Subject: **Palo Verde Nuclear Generating Station (PVNGS) Units 1, 2, 3**  
**Docket Nos. STN 50-528, 50-529 and 50-530**  
**Unit 1 Core Operating Limits Report (COLR), Revision 23**  
**Unit 2 Core Operating Limits Report (COLR), Revision 19**  
**Unit 3 Core Operating Limits Report (COLR), Revision 22**

**PVNGS Unit 1 Core Operating Limits Report (COLR)  
Revision 23**

**PVNGS Unit 2 Core Operating Limits Report (COLR)  
Revision 19**

**PVNGS Unit 3 Core Operating Limits Report (COLR)  
Revision 22**

FIGURE 3.1.5-1

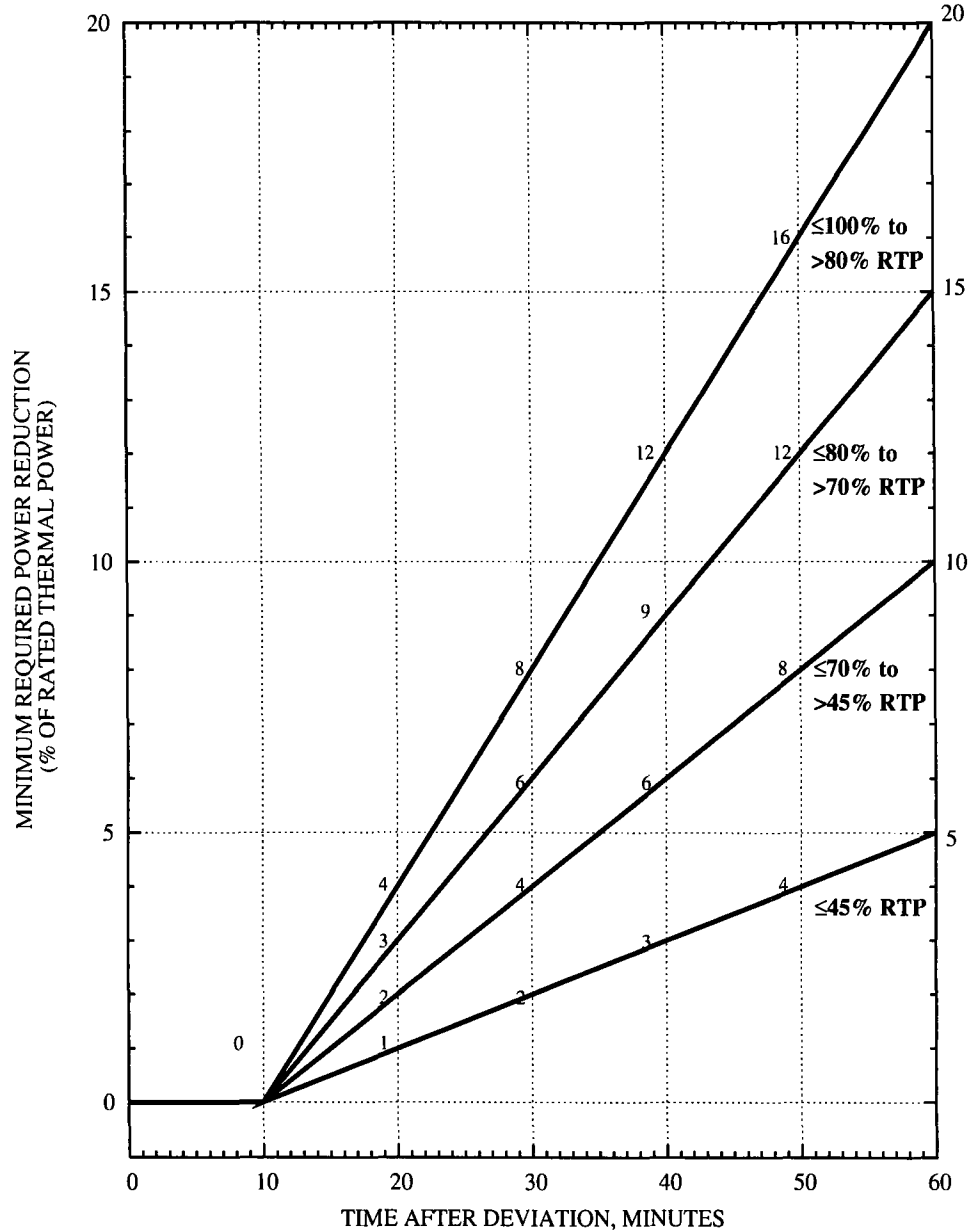
Figure 3.1.5-1 revised to include an exemption to the immediate downpower requirement, allowed if certain prerequisites are met, for a single small CEA misalignment (greater than 6.6 inches but less than 9.9 inches) in the top 9.9 inches of the active fuel region.

\* NO POWER REDUCTION IS REQUIRED FOR A SINGLE CEA MISALIGNMENT IF THE FOLLOWING CONDITIONS ARE CONTINUOUSLY MET FROM THE TIME OF DEVIATION:

- RATED THERMAL POWER IS ABOVE 95 %
- COLSS IN SERVICE AND CEACS IN SERVICE
- AZIMUTHAL POWER TILT IS LESS THAN 3.0 %
- ALL CEAS REMAIN ABOVE 142.5" WITHDRAWN BY PULSE COUNTER AND ABOVE 140.1" WITHDRAWN BY RSPT INDICATION
